(10) Patent No.: US D491,680 S (45) Date of Patent: ** Jun. 15, 2004

(54)	LUMINOUS UNIT WITH ADJUSTER					
(75)	Inventors:	Yoji Okuda, Tondabayashi (JP); Toshiyuki Nagano, Takarazuka (JP)				
(73)	Assignee:	Cateye Co., Ltd., Osaka (JP)				
(**)	Term:	14 Years				
(21)	Appl. No.:	29/190,575				
(22)	Filed:	Sep. 23, 2003				
(30) Foreign Application Priority Data						
Mar	. 28, 2003	(JP) 2003-008467				
(51) LOC (7) Cl						
(52)	U.S. Cl.					
` ′		earch				
()		362/105, 157, 158, 171–173, 183–208				
(56)		References Cited				
U.S. PATENT DOCUMENTS						
	D362,920 S					
	D373,840 S	* 9/1996 Starkman

UNITED STATES PATENT AND TRADEMARK OFFICE CERTIFICATE OF CORRECTION

FIG. 8

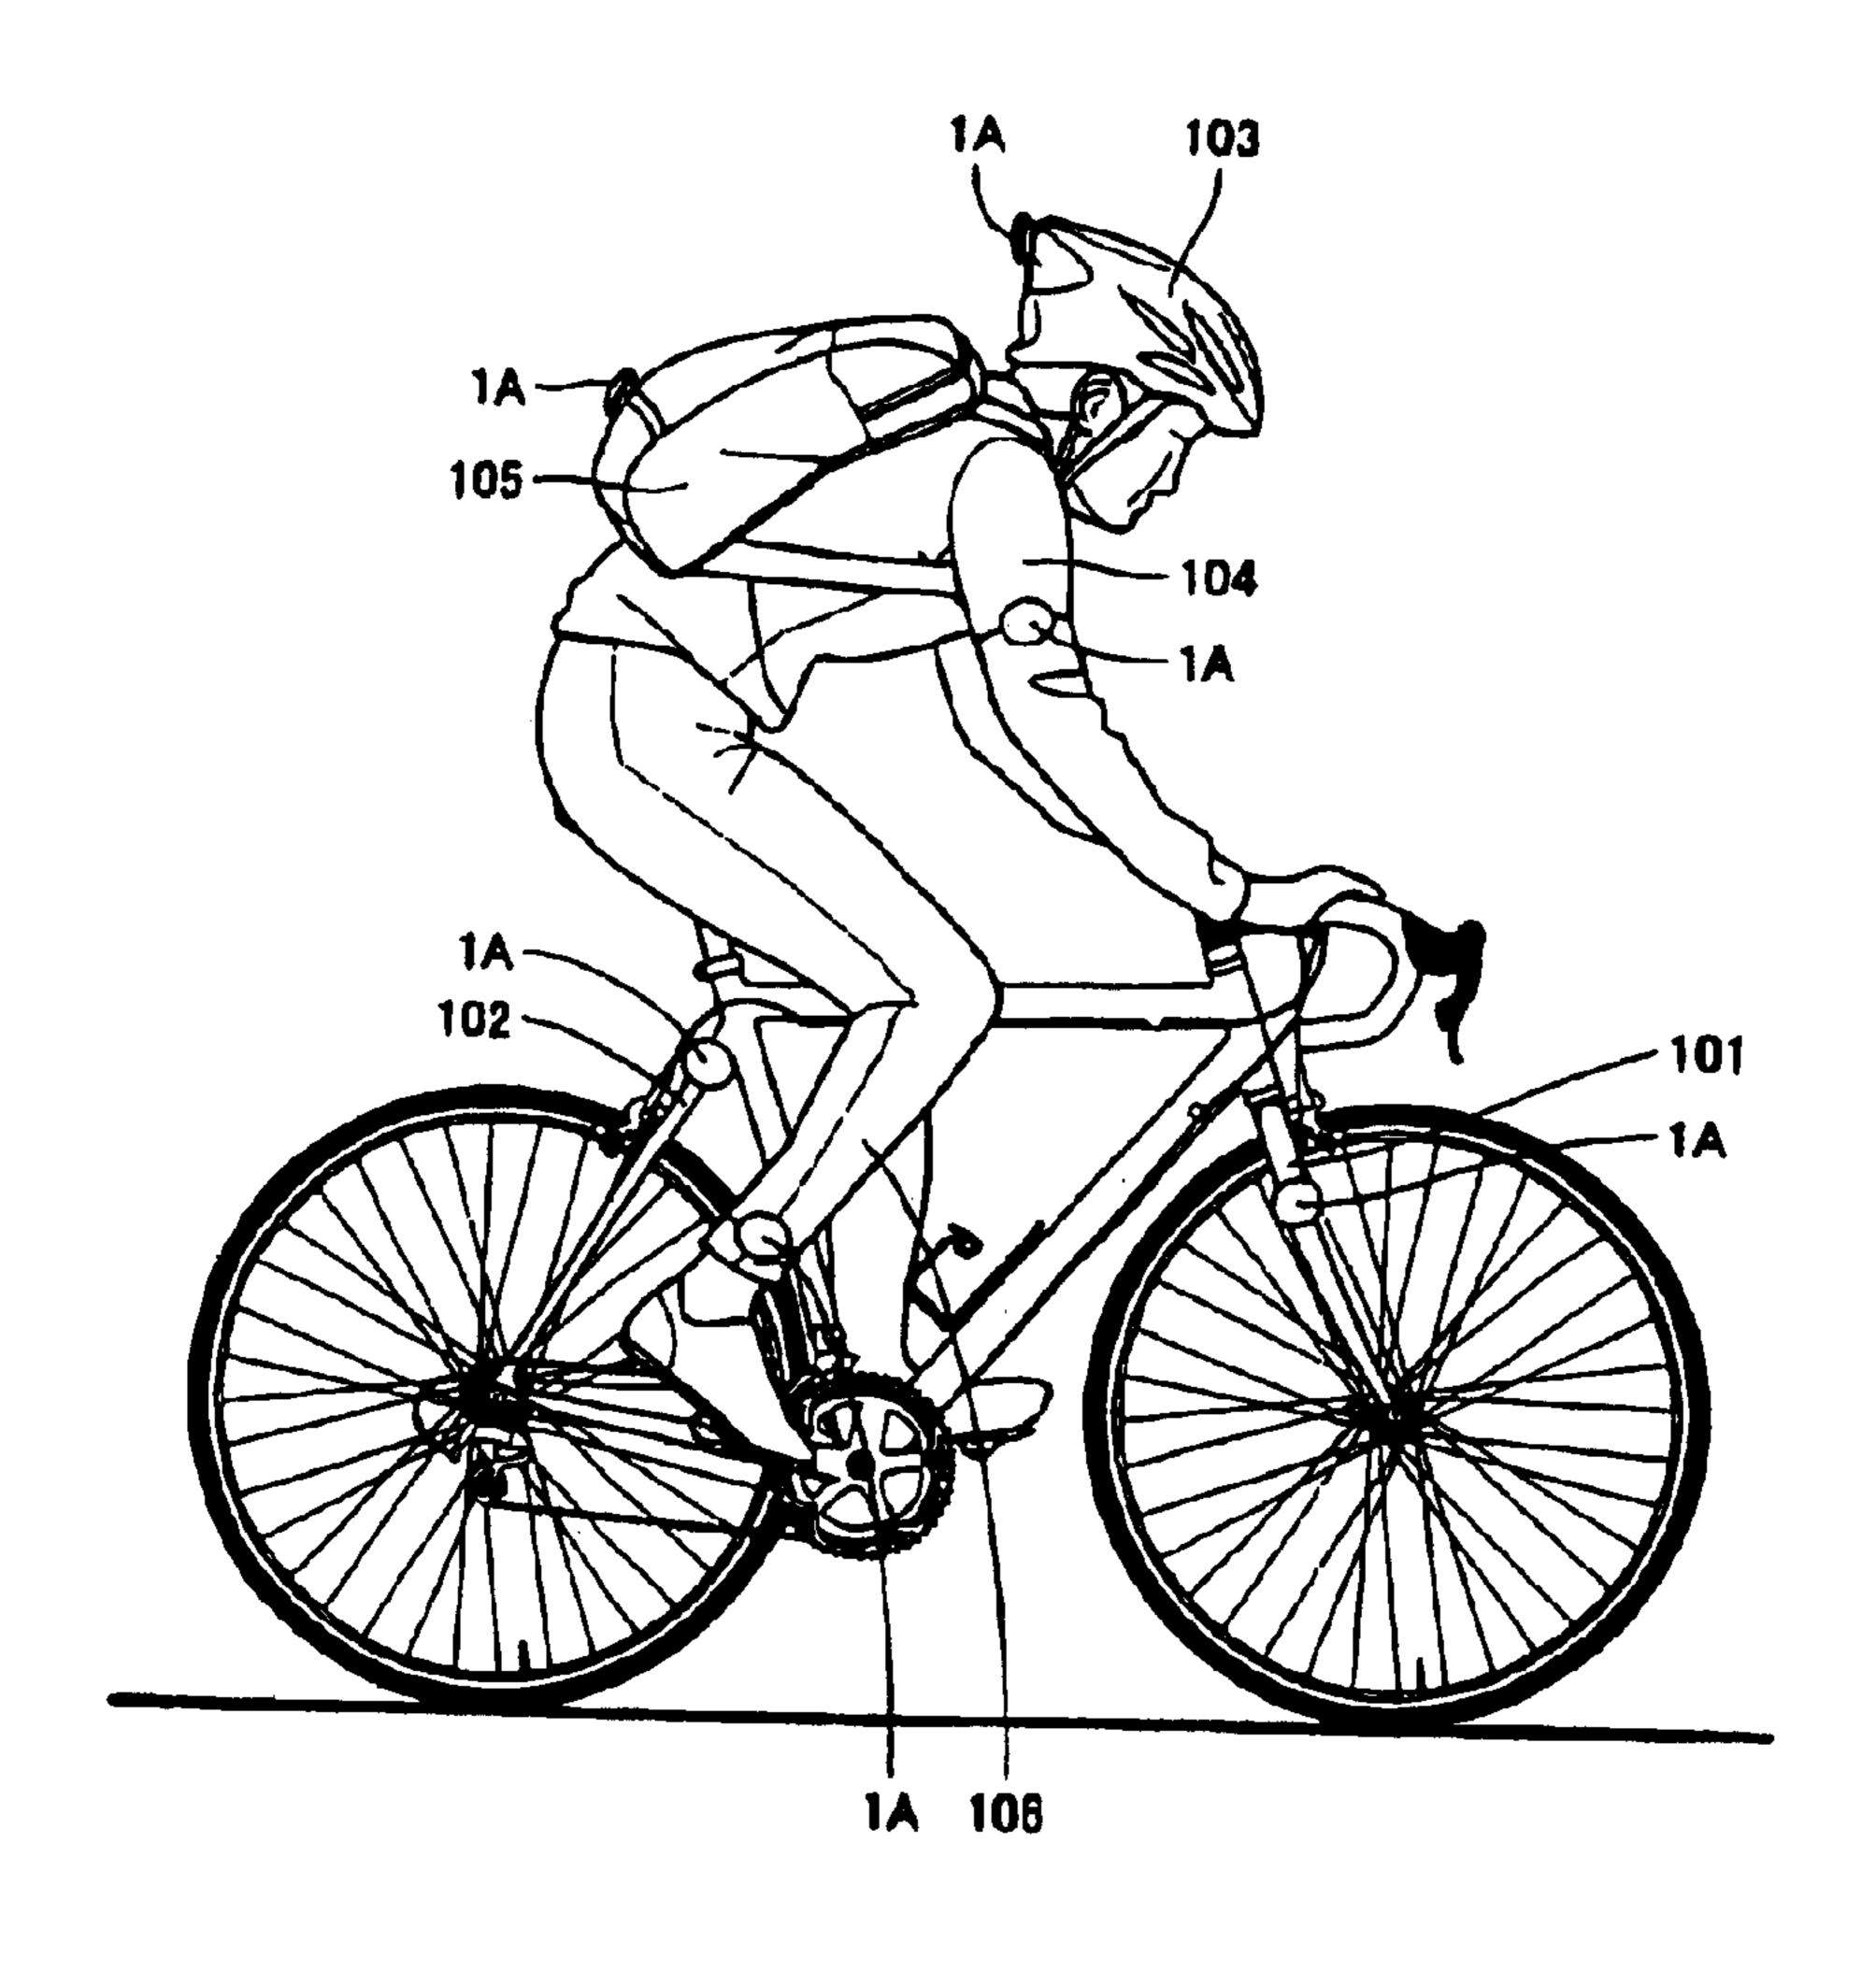
Please delete entire FIG. 8.

Please delete Sheet 4.
